# **ENERGY NORTHWEST**

July 17, 2000  
GO2-00-126

**Subject: WNP-2, OPERATING LICENSE NPF-21  
REQUEST FOR AMENDMENT  
TECHNICAL SPECIFICATIONS 3.3.5.1, 3.3.6.1 and 3.3.6.2**

**REQUEST FOR AMENDMENT  
TECHNICAL SPECIFICATIONS 3.3.5.1, 3.3.6.1 and 3.3.6.2  
Attachment 1  
Page 1 of 5**

FIGURE 1  
PRIMARY CONTAINMENT  
INBOARD ISOLATION LOGIC  
(PARTIAL)  
[TYP. FOR OUTBOARD  
SHOWN IN ( )]  
REF. FSAR  
FIGURE 7.3-8.1

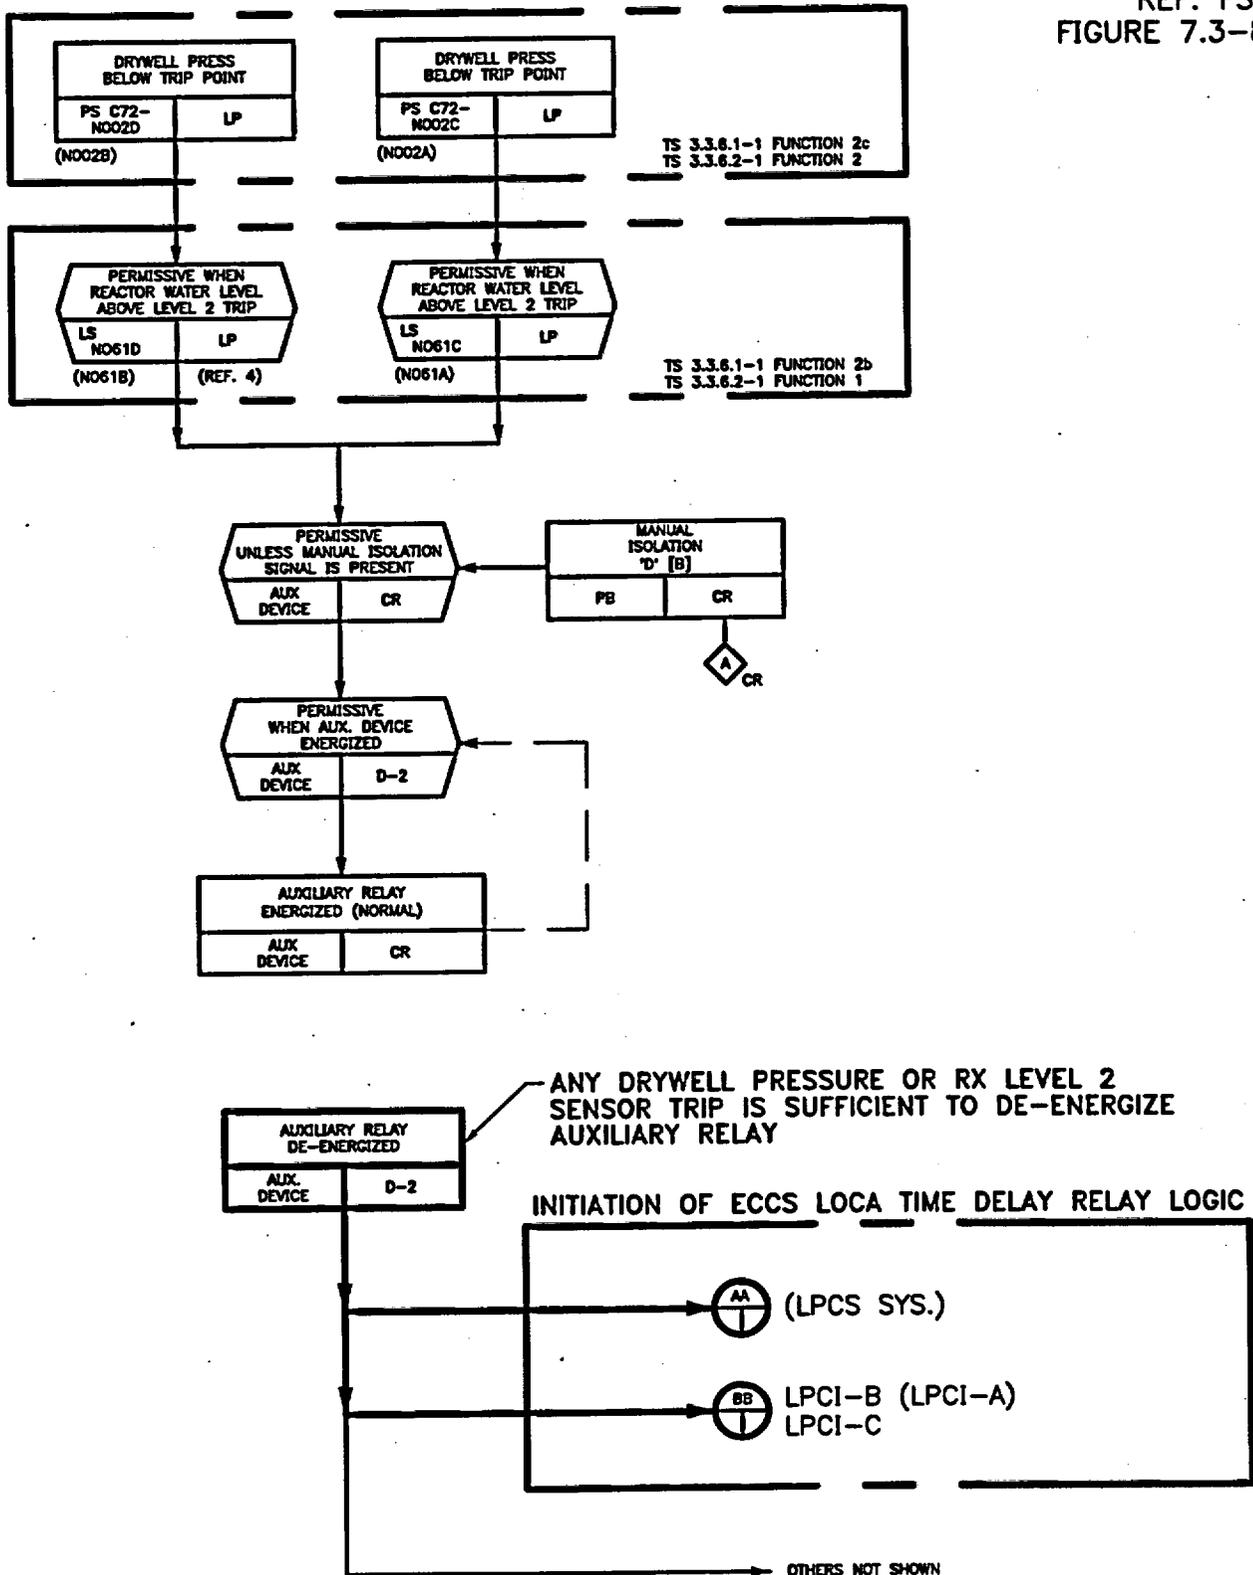
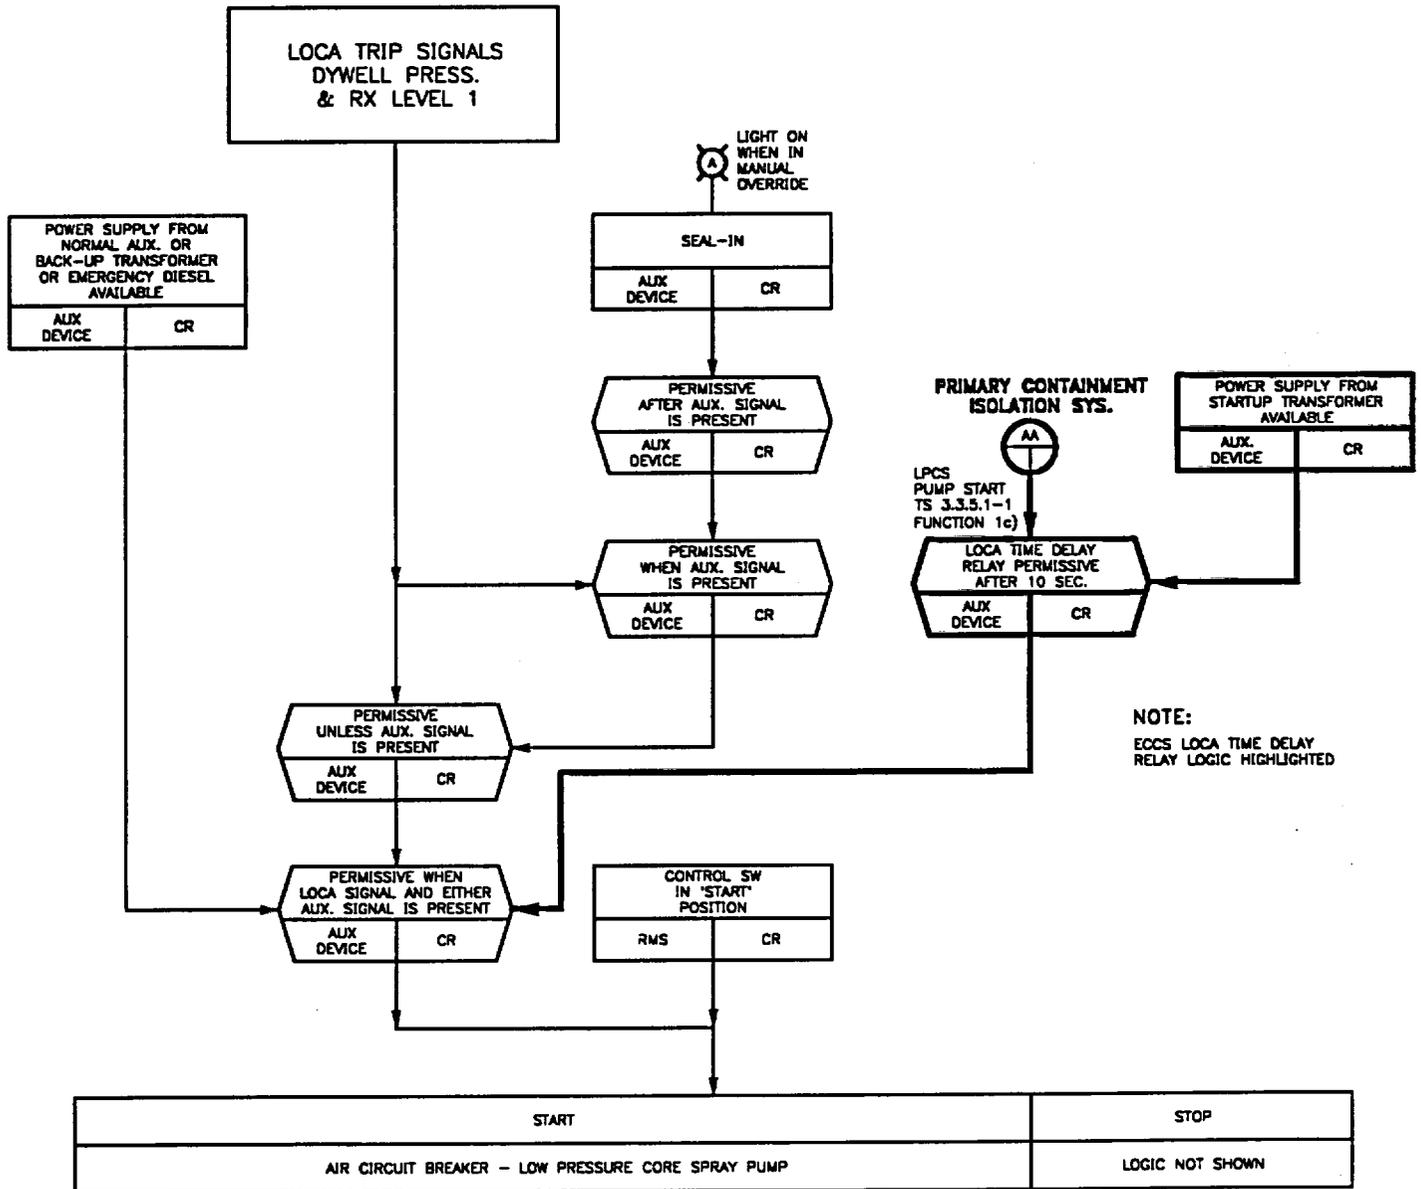
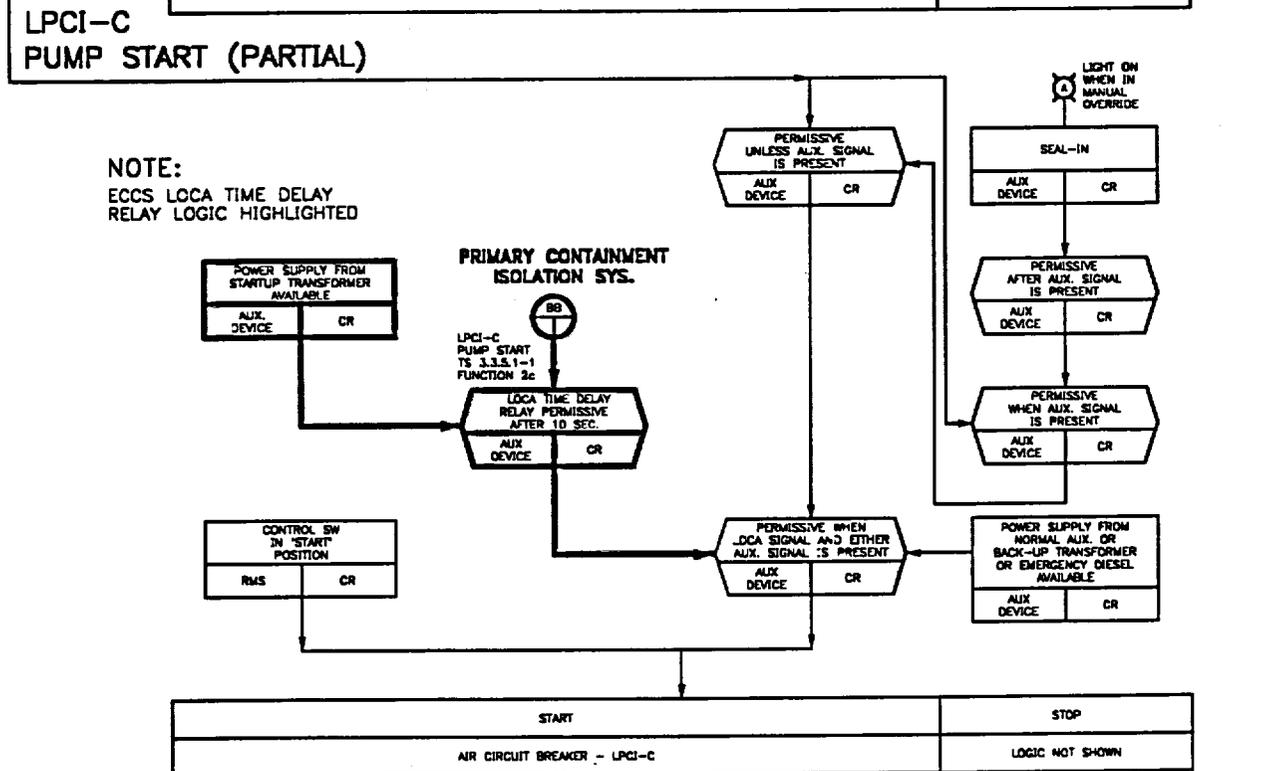
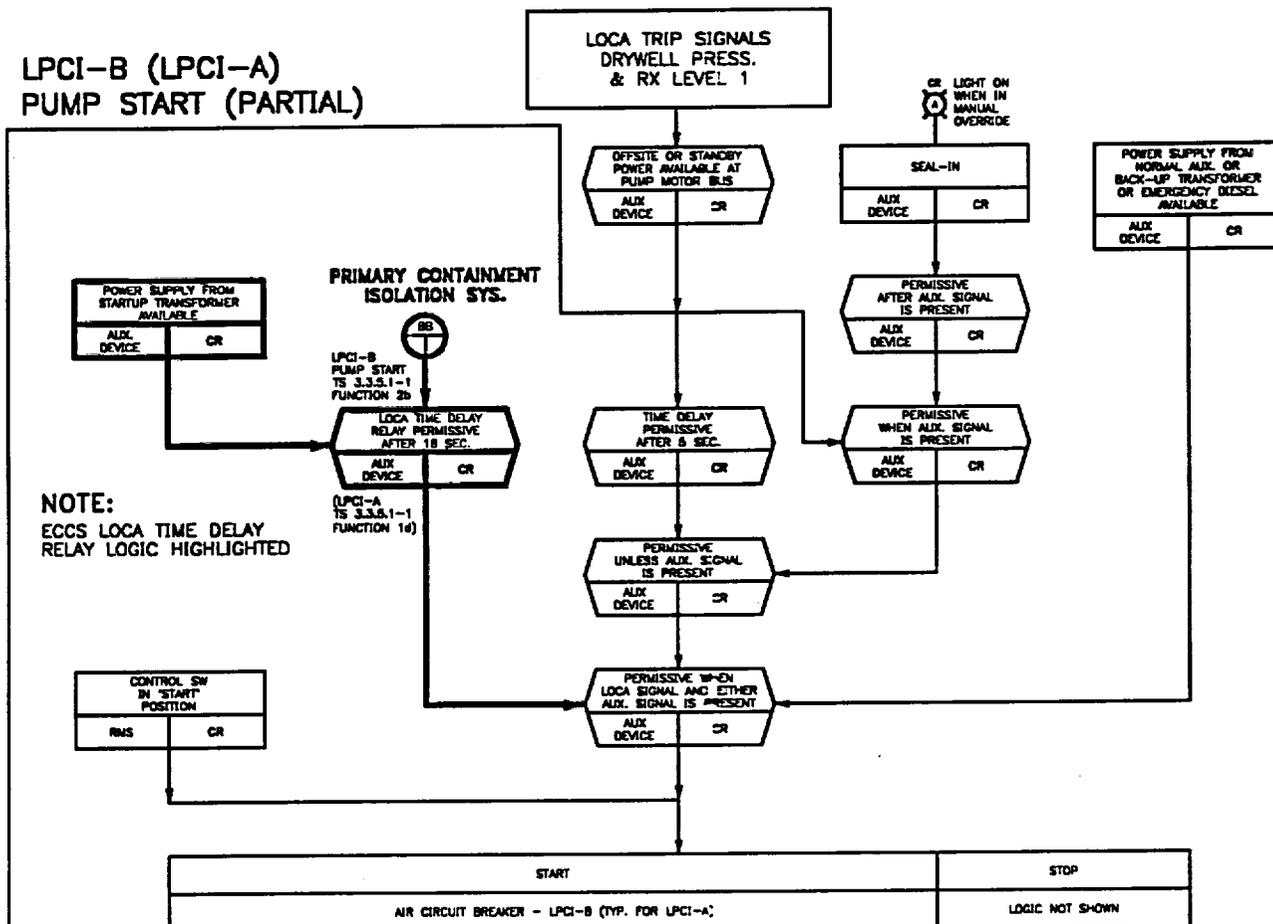
Pump-start TDR channels are included in each of the Division 1 and 2 low pressure ECCS pump-start logic trains. Each of the four low pressure ECCS pump-start designs contain a TDR relay channel initiated by a Drywell Pressure-High or a Reactor Vessel Water-Low Low, Level-2 sensor contact in series, together with other logic associated with electrical system relay and circuit breaker position. The WNP-2 design is such that actuation of any one of the sensors results in providing an actuation signal to the TDR channels for both low-pressure ECCS pumps in the same electrical division (See Figures 1-3).

In the event that one of the sensors was spuriously actuated, or was placed in the trip condition as required by any of the affected Technical Specifications (in the case of an inoperable instrument), both LOCA TDR channels in the division would receive an actuation signal. When power is aligned to the 230 kV offsite power source, the time delay relays will start and time-out, setting up the logic for simultaneous starts upon receipt of a LOCA signal (See Figures 1-3). Since the actual start of the low pressure pumps is dependent on LOCA signals that originate in other branches of the WNP-2 instrumentation systems (See Figures 2-3),

The primary and secondary containment isolation channels specified in Table 3.3.6.1-1 (Functions 2c and 2d) and in Table 3.3.6.2-1 (Functions 1 and 2) initiate the LOCA TDR specified in Table 3.3.5.1-1 (Functions 1c, 1d, 2c, and 2d). Since these Drywell Pressure and Reactor Level 2 signals are used in several functions governed by multiple Technical Specifications, we are proposing to add notes to these Technical Specifications to identify the branching to the other requirements. The note to the, "Required Channels Per Trip System," column for Table 3.3.6.1-1 Functions 2c and 2d is, "(e) Also required to initiate the associated LOCA Time Delay Relay Function pursuant to LCO 3.3.5.1." The note for 3.3.6.2-1 Functions 1 and 2 is identical, except it is labeled as Note (c). These notes will direct the operators to LCO 3.3.5.1 and a more restrictive Action.
